CHAPTER 9

RESPONSE TO COMMENTS

The Response to Comments chapter of the EIR includes comment letters for the Port San Luis Harbor Terrace Development Plan Draft EIR. These comment letters were received from entities including federal and state agencies, non-agency organizations, and the general public. In accordance with CEQA Guidelines §15132(d), this Final EIR presents the Harbor District's response to comments submitted during the Draft EIR review and consultation process.

Figure 1. Map excerpt and photo locations

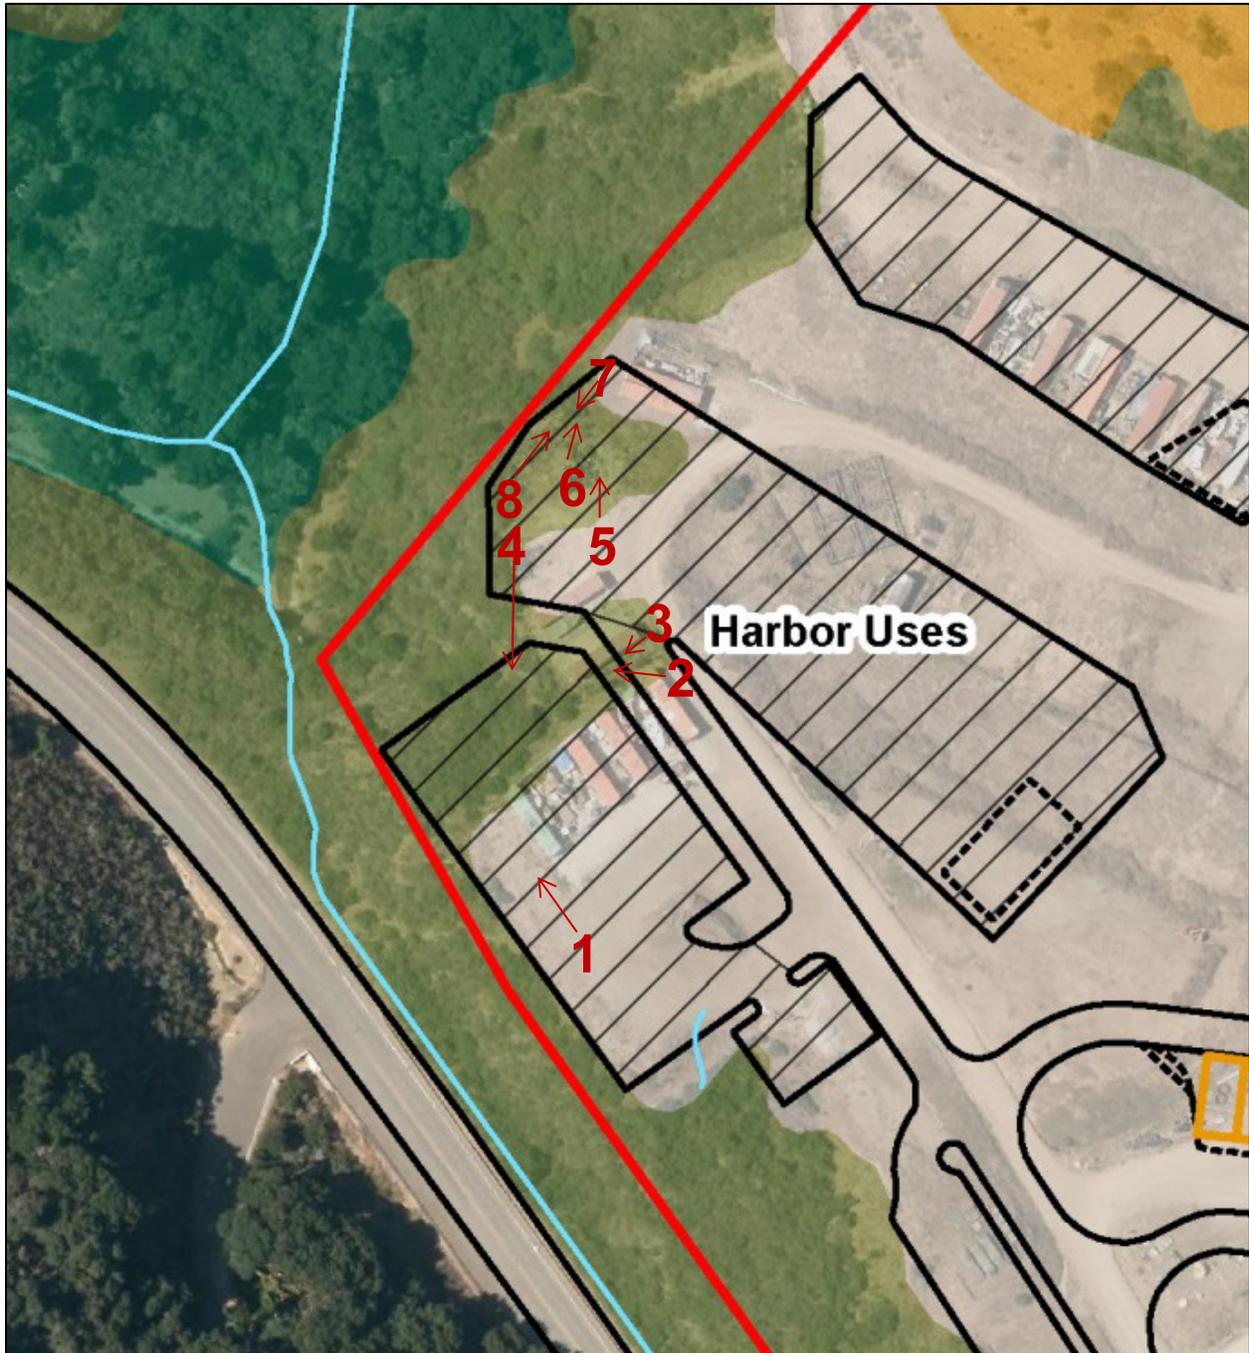
<p>component, as the existing site conditions contain hard edges, scarps, and appear heavily unnatural as seen from the beach and the pier. The proposed grading and landform alteration should create softened, natural-looking terraces and be vegetated with native plant species appropriate to this area of the coast. We note that the proposed geologic mitigation measures mention the possibility of constructing a protective wall. Any necessary geologic mitigation measures should be designed and located so as to not result in adverse visual impacts.</p>	<p>CCC-12 (continued)</p>
<p>Biological Resources. The DEIR states that the reduced project would reduce biological impacts. Specifically, the number of hotel/motel units would be reduced to 20 (from 31), and all of these units would be located in areas designated as ruderal/disturbed habitat. This reduction would address potential impacts to biological resources, including through avoidance of coastal scrub and valley needlegrass grassland habitats located in the northern portion of the project site. In addition, five marine gear storage spaces and four harbor use storage spaces would be relocated to the east of the proposed storage areas, to avoid impacts to coastal scrub.</p>	<p>CCC-13</p> <p>CCC-14</p>

As shown in EIR Figure 4.3-2 (Habitat Map with Project Overlay), coastal scrub vegetation is present within and adjacent to existing Harbor District storage use areas. Vegetation within the existing storage areas has been historically disturbed. Vegetation density and quality increases in areas downslope from the existing storage area, towards the unnamed drainage along Diablo Canyon Road and oak woodland to the northwest. Figure 1 below is an excerpt from Figure 4.3.2 showing locations of photos taken on December 23, 2014.
